Central Planning Authority

Minutes of a meeting of the Central Planning Authority held on June 21, 2023 at 10:00am in Conference Room 1038, 1st Floor, Government Administration Building, and Elgin Avenue.

CPA/14/23

Figure 1: Extent of this application overlaid on aerial imagery. Note the application is limited to only a small portion of 12D108 (Source: Submitted Plans [Job# 0922, DWG A2], Aerial Imagery Source: UKHO, 2021)

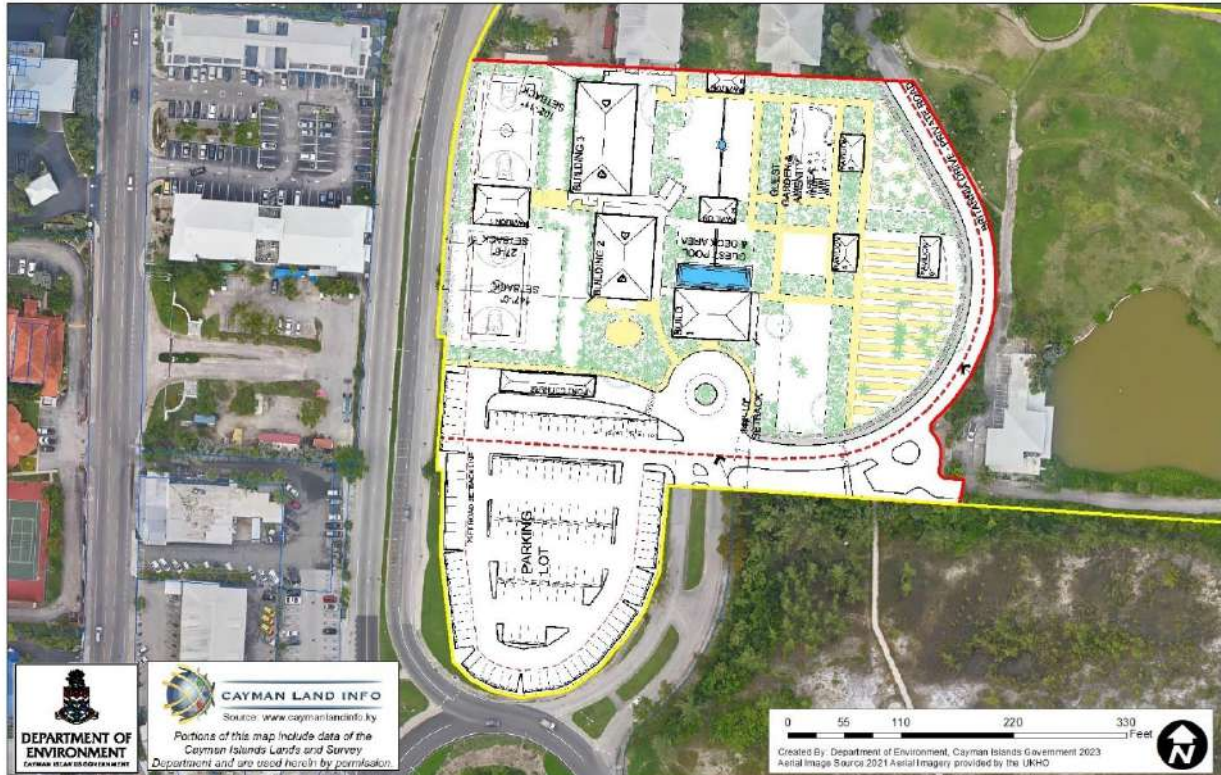
Although the site is man-modified, the redevelopment of the site offers numerous opportunities for including biodiversity and sustainability measures.

The site plan incorporates a significant amount of landscaping space. We highly recommend that native plants are incorporated into the landscaping scheme. We do note that some have been included within the landscaping palette in addition to non-native horticultural species. Native plants are best suited for the conditions of the site, including the temperature and amount of rainfall. They are climate appropriate and require less maintenance and irrigation. Landscaping with native vegetation also provides ecological benefits by creating habitat and food for native fauna such as birds and butterflies, promoting biodiversity and providing valuable ecosystem services. Native plants are also part of the identity of the Cayman Islands and can be used for placemaking and to distinguish Cayman from other places and therefore are particularly important to include in tourist facilities.

Figure 1: LIS 2018 aerial imagery with the outline of the proposed new buildings from the Applicant's site plan overlaid. Green sea turtle nests are shown in green and

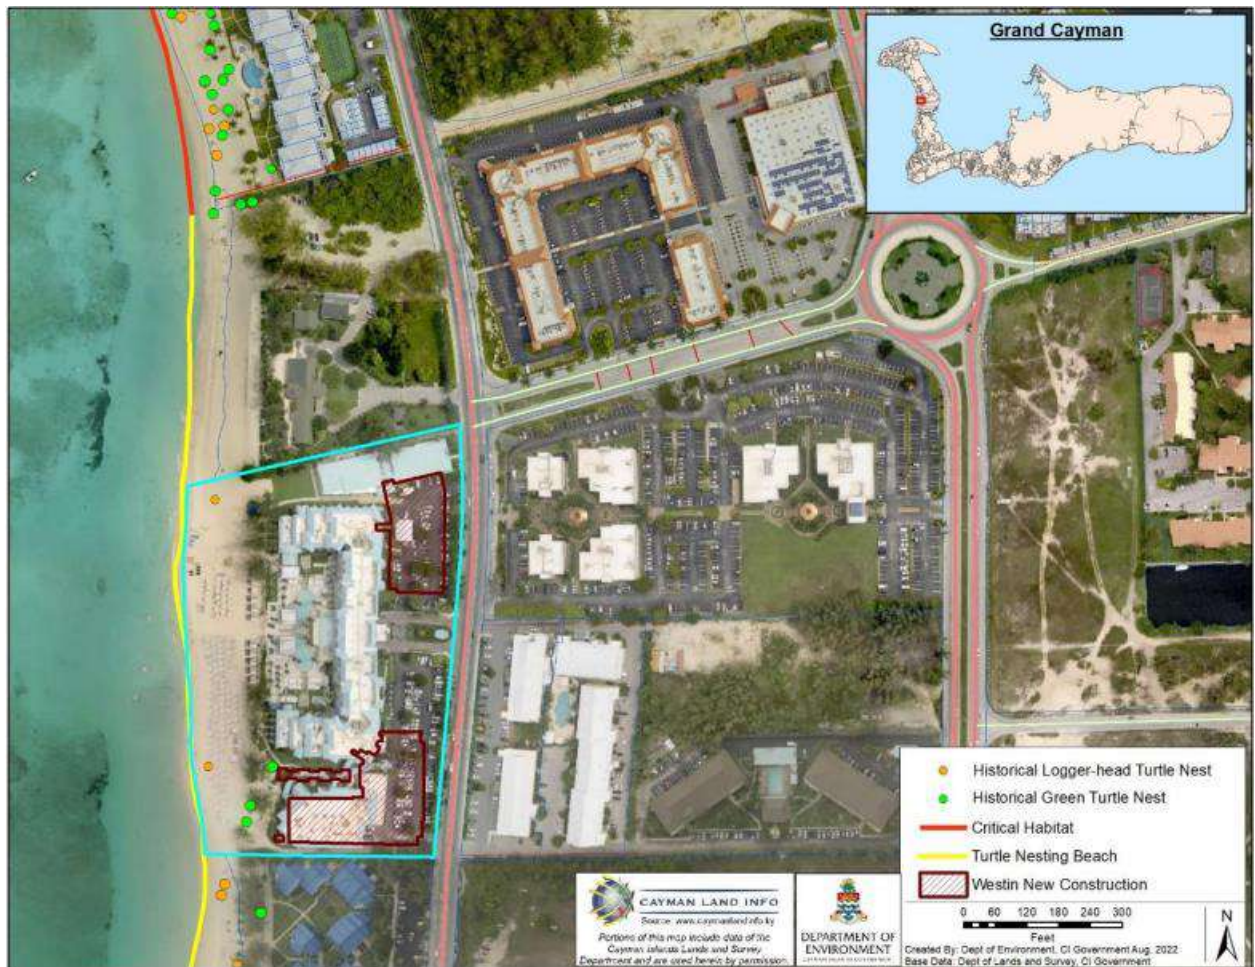
The beach of the subject parcel is a turtle nesting beach. All marine turtle species are listed in Part 1 of Schedule 1 to the NCA, as being 'protected at all times'. There are currently adverse impacts from the existing resort to nesting and hatchling sea turtles from the artificial lighting which directly illuminates the nesting beach. The Applicant has not indicated the use of turtle friendly lighting in the proposed development. Historical nesting on the site has been concentrated to the south (see Figure 1). Currently, a low-level restaurant building occupies the southern section of the resort. With the construction of the proposed 10-storey hotel tower, the impacts of artificial lighting on the historical nesting area of the beach are likely to be amplified due to the cumulative increase in lighting.

Figure 14: Digital Terrain Model (DTM) for the application site. The higher areas of the site are indicated in red and orange and show the beach ridge and sand reserves within the site.

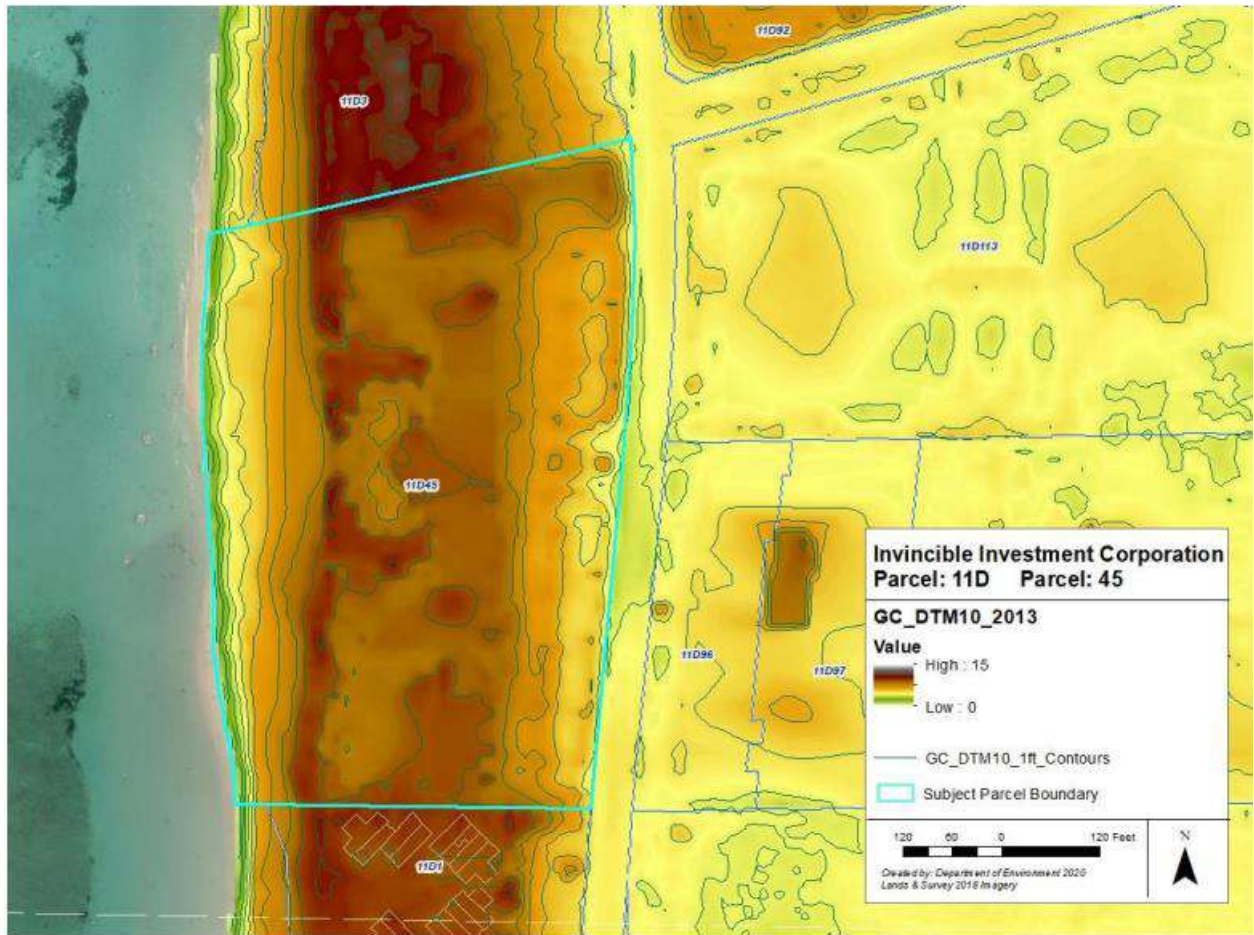
Although the subject parcel is predominantly man-modified, it still consists of massive sand reserves as shown in Figure 14 and the removal of these reserves is a concern. The reserves are important to the resilience of the beach system and are a natural source of sand which replenishes the beach profile after major storms. A significant amount of sand may result from the excavation of the foundations and pool. Once excavated and removed from the beach system, these sand reserves can never be recovered, making the beach system increasingly more vulnerable to erosion, which is exacerbated by the impacts of climate change, especially sea-level rise. We recommend that any excavated sand is kept on-site and placed landward of the High-Water Mark to retain sand reserves and create depth in the beach profile.

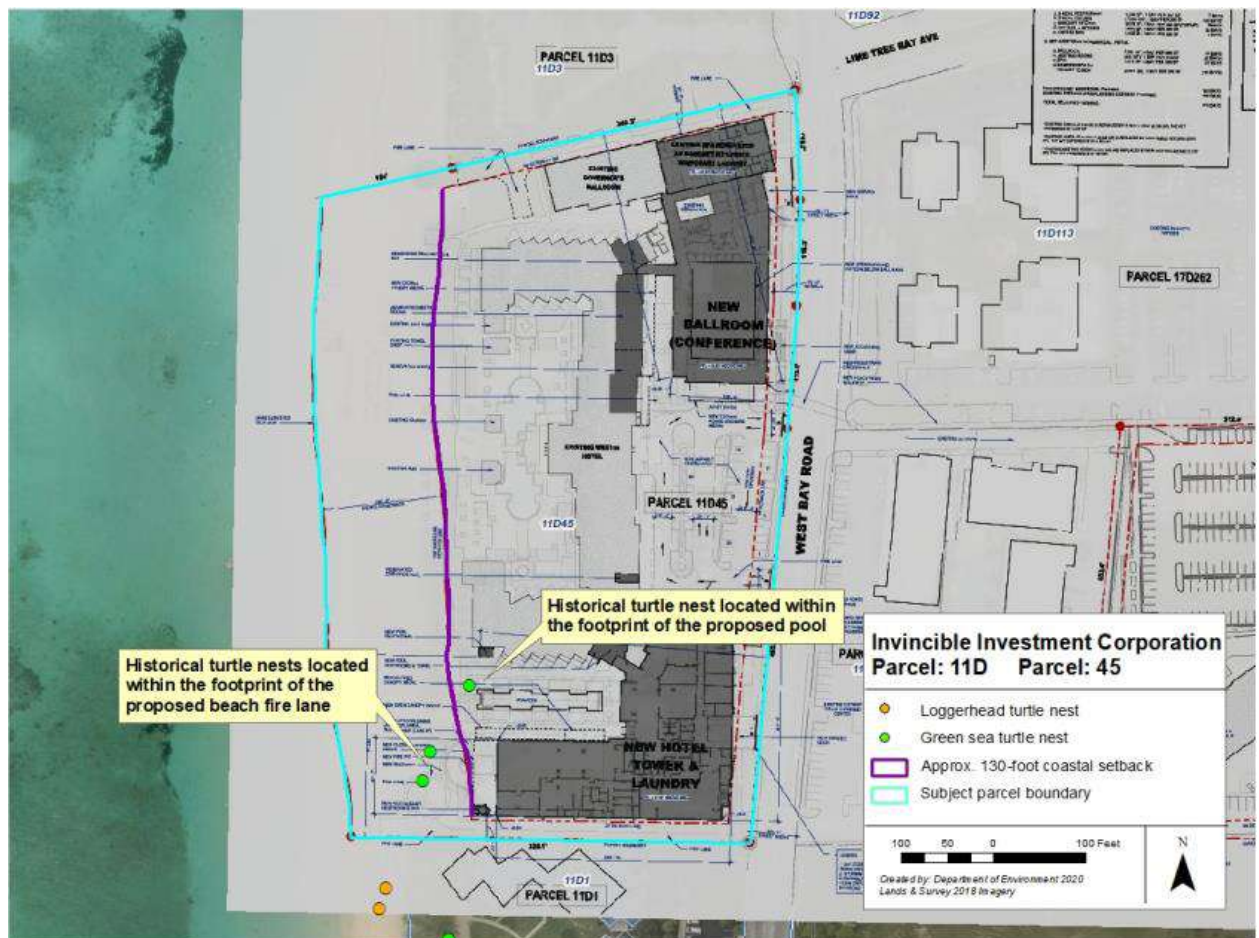
*The site is located on a sea turtle nesting beach, located approximately 253 feet from proposed Critical Habitat under the Draft Conservation Plan for Sea Turtles (2019), see Figure 1. Based on the DoE's 20 years of monitoring sea turtle populations, the site has experienced nesting from green (*Chelonia mydas*) sea turtles in the past however there is still the potential for loggerhead (*Caretta caretta*) sea turtles to also nest on the beach. There are currently adverse impacts to nesting and hatchling sea turtles from the artificial lighting which directly illuminates the nesting beach from the existing resort. The Applicant has not indicated the use of turtle friendly lighting in the proposed development. Historical nesting on the site has been concentrated to the south (see Figure 2). Currently, a low-level restaurant building occupies the southern section of the resort. With the construction of the proposed 10-storey hotel tower, the impacts of artificial lighting on the historical nesting area of the beach is likely to be amplified due to the cumulative increase in lighting.*

The Applicant has not requested any variances to the Development and Planning Regulations coastal setbacks, however, as shown in Figure 2, portions of the proposed pool deck, the proposed outdoor seating area and the proposed fire lane are all located within the 130-foot setback from the Mean High Water Mark. These areas of the proposed development also have historical turtle nests located within their footprints. Hard structures located within the 130-foot setback e.g. the fire lane on the beach, decrease the size of the potential turtle nesting habitat.

Figure 3: Location of the application site and neighbours. The image illustrates the similar coastal setbacks of the application site (circled in red) and the properties to the north and south.

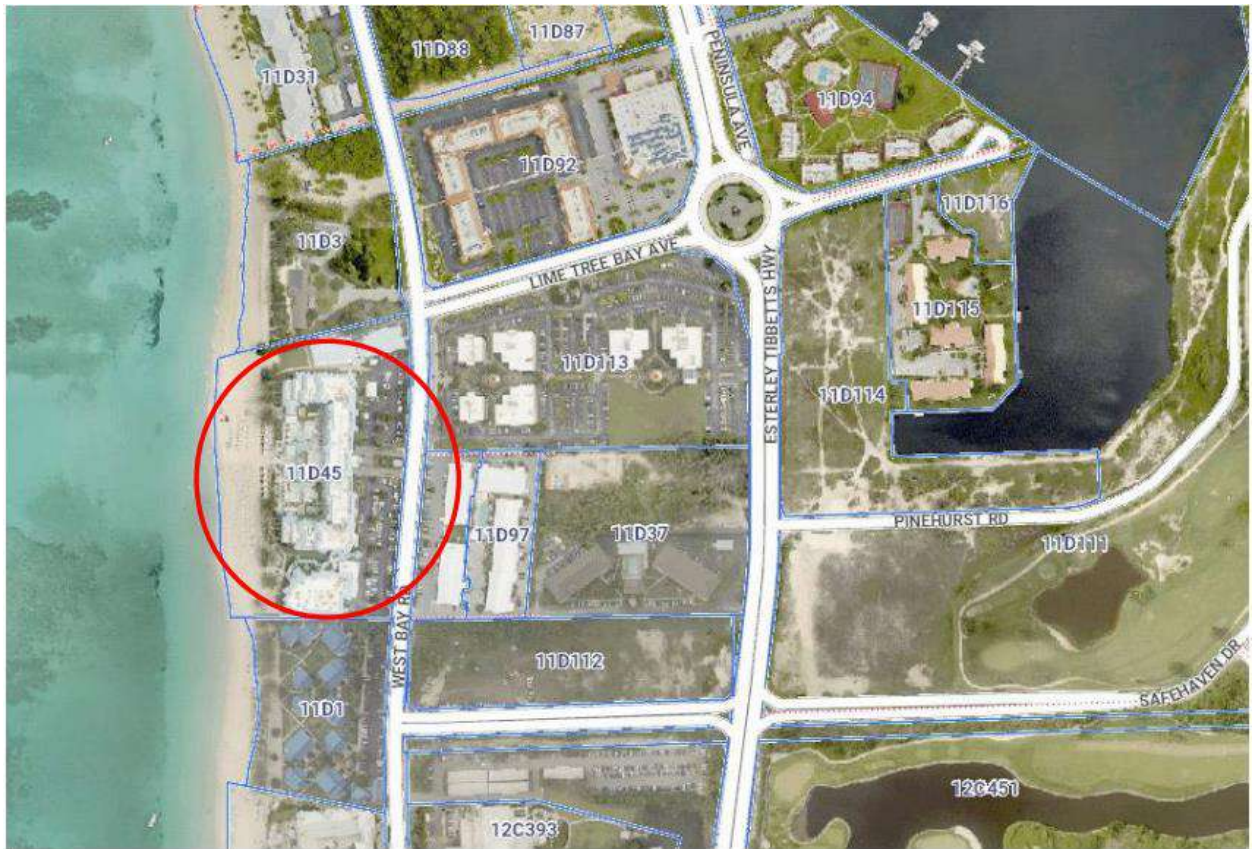
The proposed development will be set back 20 feet from the northern and southern parcel boundaries. The neighbouring property to the north (The Governor's House) is located a little over 20 feet from their southern boundary. The southern neighbouring property's (Villas of the Galleon) northern side setback ranges from 8 feet to 14 feet. The application site and the neighbouring properties to the north and south all have a similar setback from the Mean High-Water Mark ranging from 120-160 feet (see Figure 3).

With the demolition of the southern single-storey building and the construction of a 10-storey hotel tower in its place, even if repositioned to comply with the minimum required setback under the Development and Planning Regulations, it will be very visually prominent on the beach. When the proposed 10-storey hotel tower is constructed it may block daylight, sunlight and views from the northern units of the neighbouring residential property to the south (Villas of the Galleon) (see Figure 4).

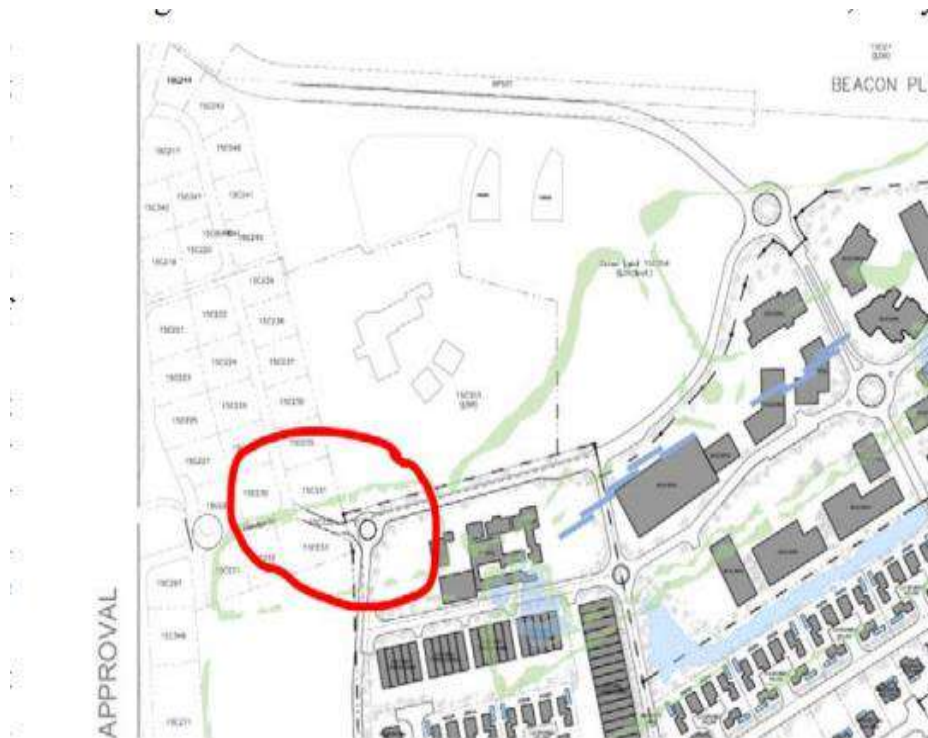
The proposed main entrance to the subject lands is located on a the partial built road to the Fairbanks Prison, that forms part of Boundary Plan 643 / Prescribed Composite Map 344 (gazetted in January 2022). The developer has agreed to contribute to the construction cost of the access road with the Cayman Islands Government for the first phase of the gazetted road from Fairbanks Road to the proposed roundabout which provides access to CEC's first development phase. From the time this development was planned as a PAD, the planned roadway network for the South Sound By-Pass (gazetted in May 2005) was altered by the NRA to accommodate an outer curve between Block 15C Parcel 56 to Block 15C Parcel 353 (this is now reflected in the proposed Section 26 gazette) as shown in the following graphics.

The developer is now proposing an alteration to the planned road corridor by introducing a proposed roundabout that would allow a road connection from the CEC project to Fairbanks Road via Fairview Road as illustrated on the right. Fairlawn Road is classified as an Access Road, thirty (30) feet in width; it serves as the local access road to about 20 residences, and it intersects with Fairbanks Road with a less than optimal angle. In other words, this roadway is not conducive and of sufficient width to accommodate significant traffic demand generated by the CEC Campus, especially the institutional traffic shown as Inst Phase 4.1 on the Phasing Plan (drawing A.101. On that basis, the NRA cannot endorse the use of Fairlawn Road as an alternative means of access to the CEC Campus. The NRA therefore asks the CPA to require the developer to remove this access point from drawings A-100 – Proposed Master Plan and No A.103 – Use Zoning Masterplan.

Figure 1: Topography of South Sound drainage basin (outlined in red) and location of

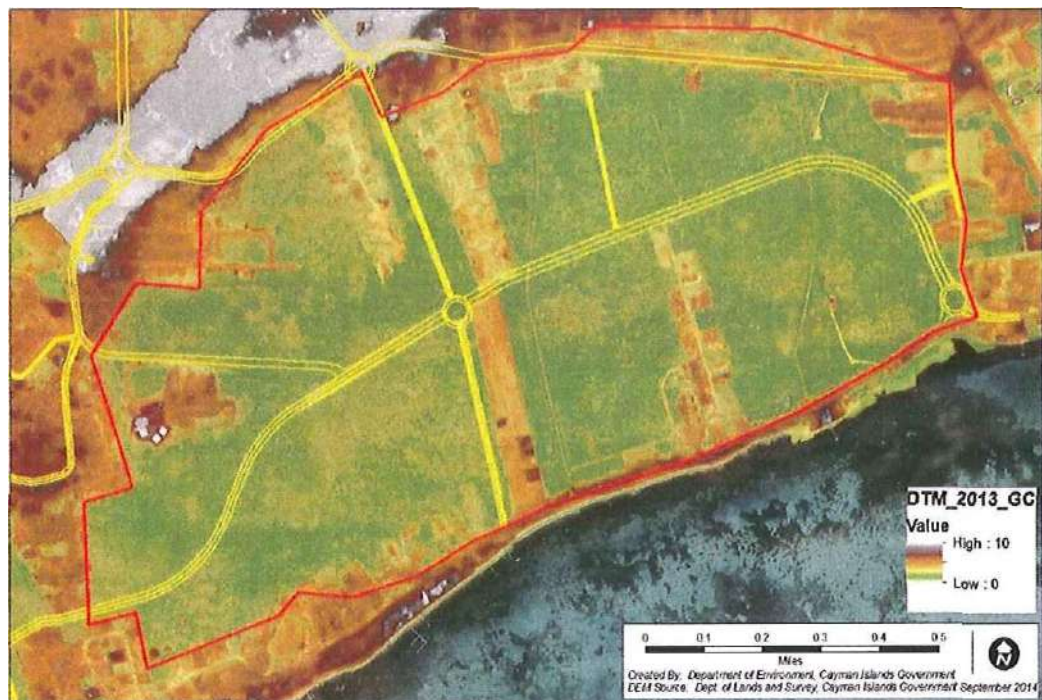
Proposed and existing developments including new roads in the South Sound drainage basin are shown in Figure 1 and Figure 2.

Figure 1: DOE's 2013 habitat map extract showing the application site outlined in red.

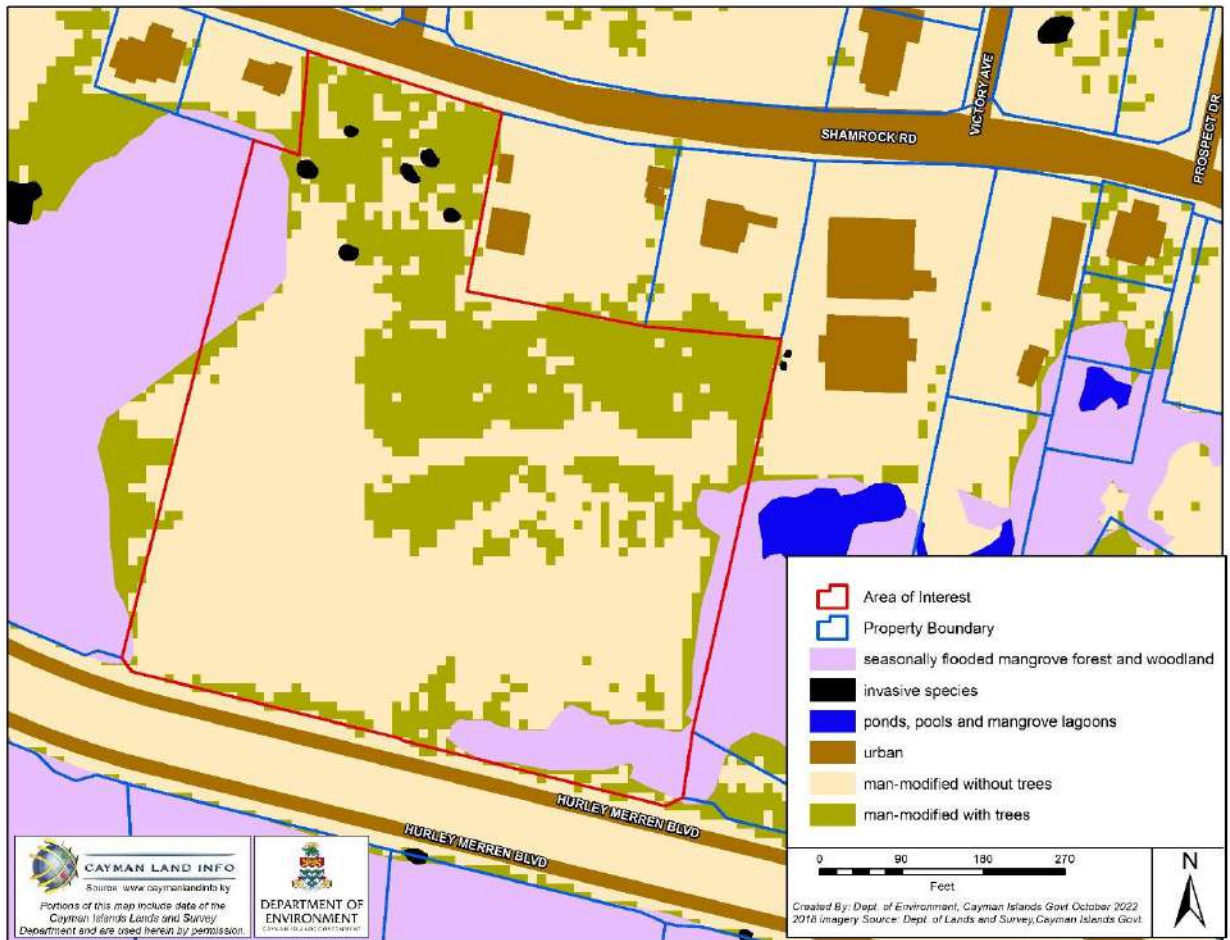
The application site is man-modified with some regrowth as shown in Figures 1 and 2. We note that this application is for the modification of a commercial development which received planning approval at CPA Meeting (CPA/10/18) held May 2, 2018 (Planning Ref: F18-0090, P18-0196). However, the Department of Environment (DoE) was not consulted on the previous application for this site, and therefore was not afforded an opportunity to provide comments for the initial application.
